Access Compliance Report Public Rights-of-Way (Curb Ramps)

Intersection ID: 50342 Main Street: HERMISTON_ST **Cross Street: STIRLINGSHIRE CT** Location: SW ADA ID: E8116EE2D5C1 Ramp Type: BlendTrans1 Initial Pass/Fail: Fail **Overall Compliance: No Severity Score:** 12.5

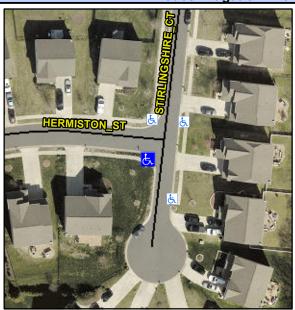
Not Found, R304.5.3

Compliance Description		Data	Comp	liance	Description	Data
N/A	Ramp Length (in)	50.0	Yes	Blend	Trans Slope (%)	3.2
Yes	Ramp Width (in)	48.0	No	Blend	Trans XSlope (%)	5.3
N/A	Flare Type LT	N/A	N/A	Flare	Type RT	N/A
N/A	Flare Slope LT (%)	N/A	N/A	Flare	Slope RT (%)	N/A
N/A	Flare Traversable LT?	N/A	N/A	Flare	Traversable RT?	N/A
N/A	Landing Length (in)	N/A	N/A	DWS	Provided?	N/A
N/A	Landing Width (in)	N/A	N/A	DWS	Contrast?	N/A
N/A	Landing Slope (%)	N/A	N/A	DWS	Length (in)	N/A
N/A	Landing X Slope (%)	N/A	N/A	DWS	Full Width?	N/A
N/A	Landing Curb? (Y/N)	N/A	N/A	DWS	Offset (in)	N/A
N/A	Shared Landing?	N/A				
N/A	Gutter Ponding?	N/A	N/A	Gutte	r Slope (%)	N/A
N/A	Gutter Lip Ht (in)	N/A	N/A	Gutte	r X Slope (%)	N/A
N/A	Painted X Walk1?	No	N/A	Painte	ed X Walk2?	No
	X Walk 1 Direction	To E		X Wa	lk 2 Direction	To N
	X Walk 1 Width (in)	N/A		X Wa	lk 2 Width (in)	N/A
	X Walk 1 Slope (%)	5.8		X Wa	lk 2 Slope (%)	2.2
	X Walk 1 X Slope (%)	0.3		X Wa	lk 2 X Slope (%)	6.0

Possible Solutions: Remove & Replace Curb Ramp With Two New Directional Ramps or Equivalent.
